AP1000 Design Certification Review

Draft Safety Evaluation Report Open Item Response

DSER Open Item Number: 15.2.7-1 Item 10 (Revision 2)

Figure 1 – IRWST / Containment Recirc Sketch

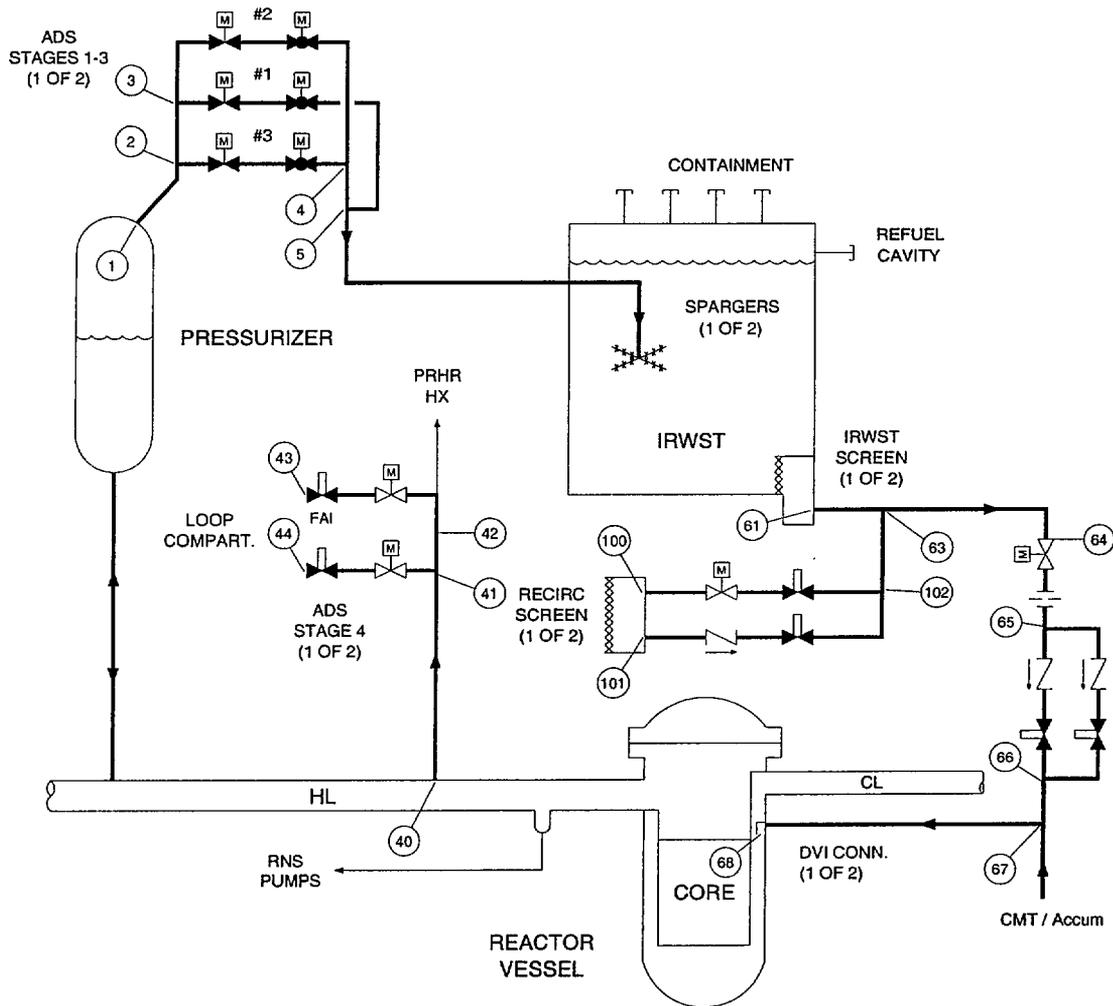
The NRC staff is attempting to modify the RELAP5 AP1000 model to evaluate LTC. The current model does not model sump recirculation into the DVI lines. Please provide the following ...

The file below has two sketches that provide the loop configuration that N. Lauben was asking about in the telecon today. We will submit these formally as revised response to this OI.
